**Interim Corrective Measures -
Groundwater Recovery and Treatment
System
Post Closure Monitoring Work Plan
Franklin Power Products Site
Franklin, Indiana**

Reference: EPA Contract No. 68-W4-0006; EPA Work Assignment No. R05033; Franklin Power Products - Former Amphenol Corporation, Franklin Indiana; U.S. EPA ID No. IND044587848; Review of the Report of an Evaluation of the On-Site Recovery System; Task 03 Deliverable

Subject: Report of Onsite Recovery System Evaluation Activities at the Former Amphenol Facility; May, 1997

Figure 6.4 Calculated Characteristic Curve of Recovery Well RW-2

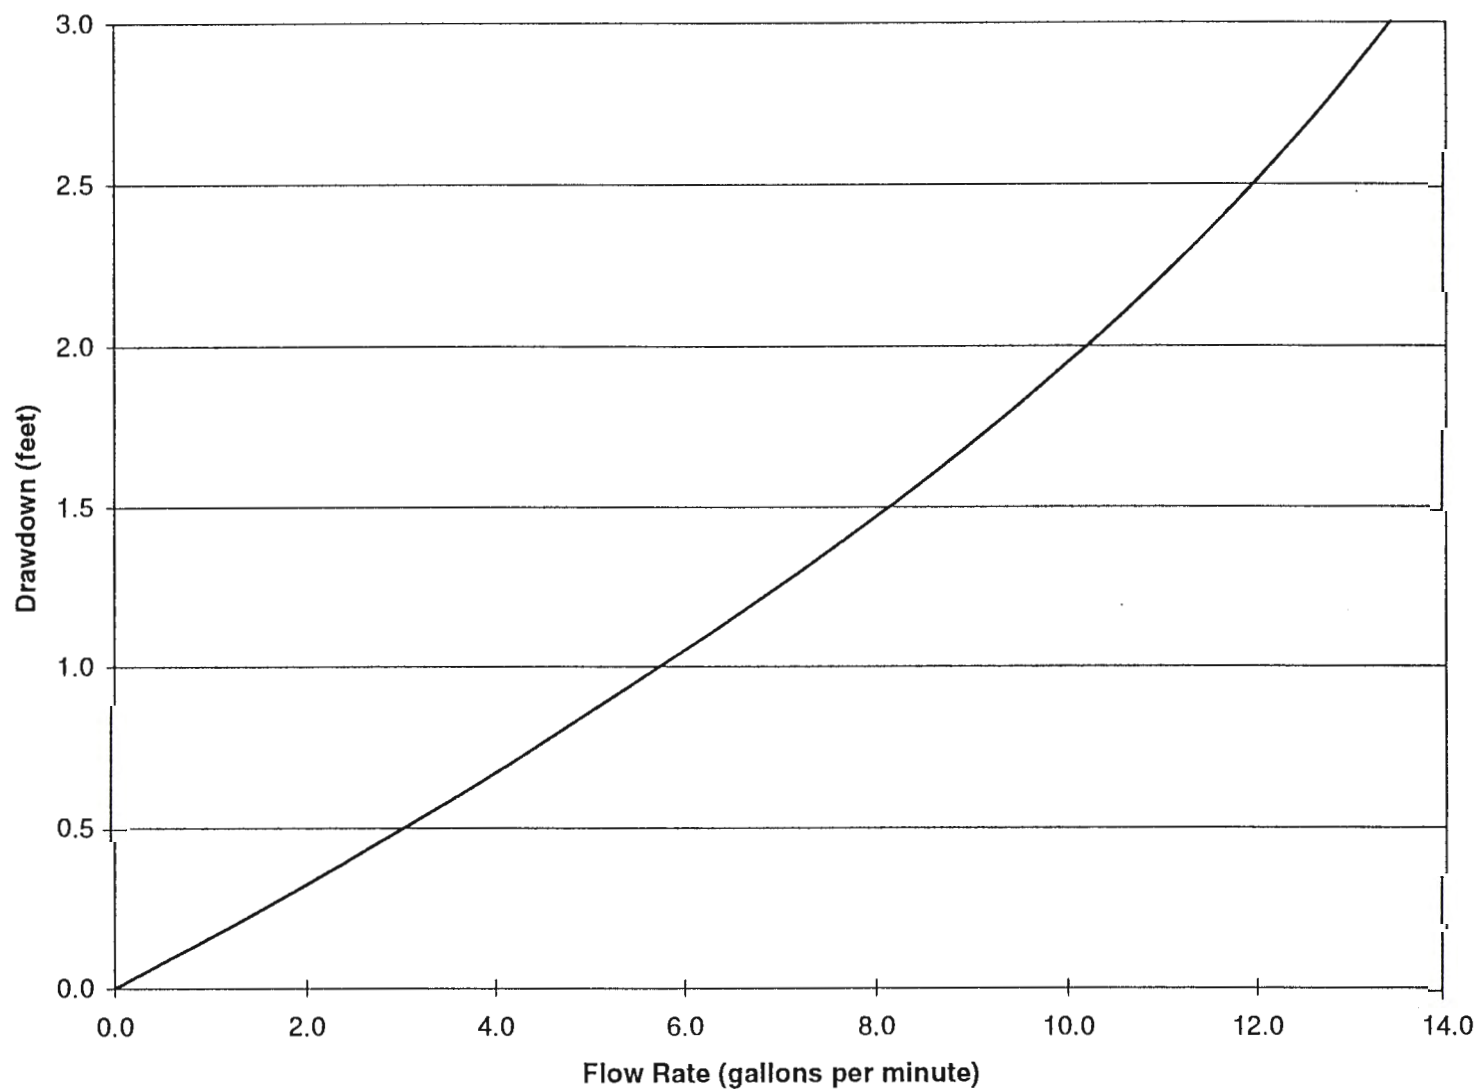
The most notable modification is the replacement of the currently installed pneumatic pumps with smaller electric pumps with equal or greater pumping capacities. The current pumps possess significant limitations since the overall length of the pump and the location of the pump intake severely limits the amount of drawdown that can be accomplished. The proposed replacement of the pneumatic pumps with electric submersible pumps that are much shorter, will allow the pump intakes to be placed much lower in the well. This will effectively allow the pumping rates (and resultant drawdowns) to be increased, by an as yet to be determined amount, thus providing more control over the movement of the plume and the groundwater surface elevation as it relates to the storm sewer invert.

This modification along with the installation of an additional recovery well may result in the ORS achieving the specified goals. However, the effectiveness of the new pumps will have to be evaluated shortly after installation to determine whether operation of the ORS is actually containing migration of contaminated groundwater in the area. If further evaluation of the system concludes that the pumps do not exhibit the necessary control over the groundwater contaminant plume and/or elevation, the next recommendation may be to install up to two additional recovery wells to the east and west of RW-1 and RW-2 respectively. These additional wells would be preferred over the installation of deeper wells since the well screens on the existing recovery wells already extend to the base of the Unit B aquifer. The additional wells would increase the drawdown of the groundwater table over a wider area to ensure that the water table was below the invert of the storm sewer along its entire length.

As shown in Figure 6.4, the characteristic curve for drawdown vs. pumping rate at RW-2 indicates that pumping rates from 10 to 13 gpm are needed to sustain a drawdown of 2 to 3 feet at this location. Cumulative pumpage data indicate average pumping rates of 1.5 gpm for RW-1, 2.0 gpm for RW-2 and 2.8 gpm for RW-3 since August 4, 1995. Assuming that the data for RW-2 are generally applicable to the other recovery wells, the pumping rates achieved to date are not adequate to achieve the draw down needed to maintain capture zones and lower the potentiometric surface below the storm sewer inverts.
